SERVICE BULLETIN

NACELLE POWER PLANT - FAN COWL DOOR - HOLD-OPEN STRUT BRACKET - REWORK OF - CATEGORY
CODE 4 - MOD.NAC-71-0102

V2500-NAC-71-0102

Inlet Cowl Family Tree
Fig.1

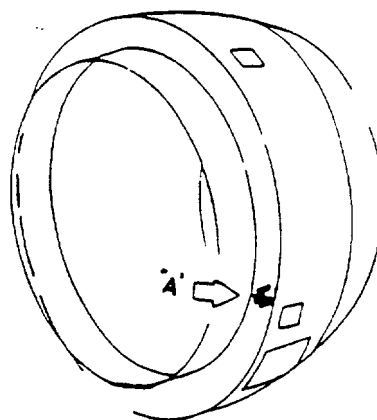
Refer to Figure 1.

Removal/Installation of Hold-Open Strut Bracket
Fig.2

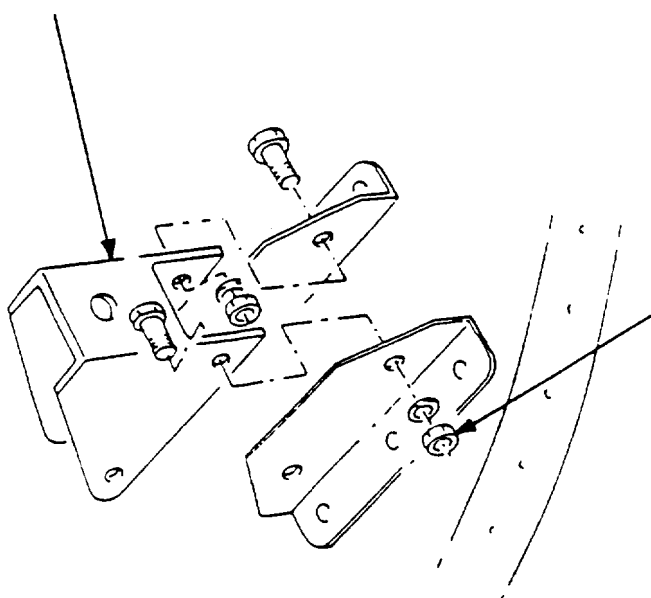
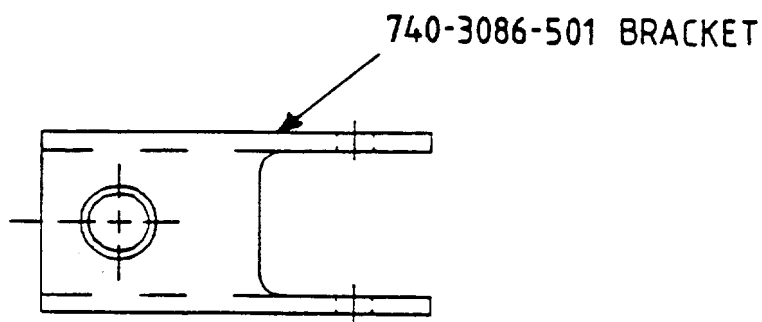
- (a) The hold-open strut bracket on the rear bulkhead of the inlet cowl is removed. The bracket is modified and reinstalled (ref: Figures 1 AND 2).

- (1) Remove four A104-0-5D bolts, four AN960-C10L washers, and four AS8623-D nuts to release the 740-3086-501 bracket. (Refer to Figure 2.)
- (2) Cut the corner off the 740-3086-501 bracket to form the 740-3086-503 bracket. (Refer to Figure 3.) Remove any burrs from the bracket and identify it to the new part number 740-3086-503 with a vibro-etch engraver.
- (3) Install the 740-3086-503 bracket with the four bolts, four nuts, and four washers kept in paragraph 2.B.(1). Torque the nuts to 40 lb-in. (4.52 N.m). Engage the hold-open strut-rod in the new bracket and examine for a satisfactory clearance.
- (4) Reidentify inlet cowl from 740-3000-585 to 740-3000-593.

NOTE: MODIFY THE BRACKET TO NEW
PART NUMBER STANDARD
(REF FIGURE 2)

REMOVE
740-3086-501 BRACKET
INSTALL
740-3086-503 BRACKET

REMOVE AND INSTALL
A104-0-50 BOLT (4)
AN960-C10L WASHER (4)
AS8623-D NUT (4)

To change the Hold-Open Strut Bracket
Fig.3

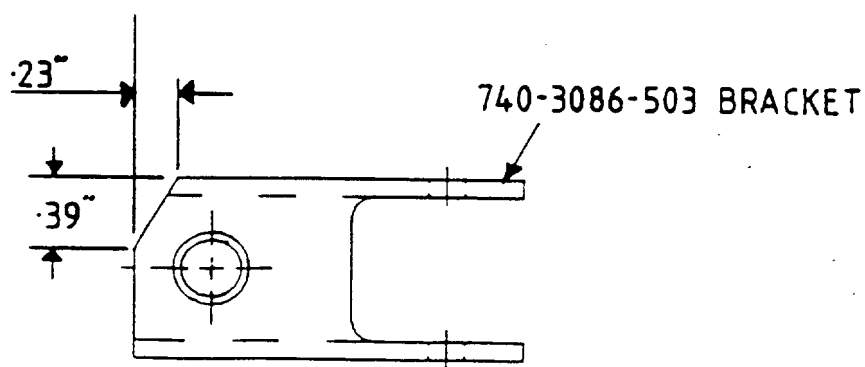
The bracket for locating the forward hold-open strut-rod on the right fan cowl door may cause a foul with the insulation blanket around the gimbal joint on the TAI air supply pipe.

IDENTIFY THE MODIFIED BRACKET
TO 740-3086-503 WITH A VIBRO-ETCH ENGRAVER
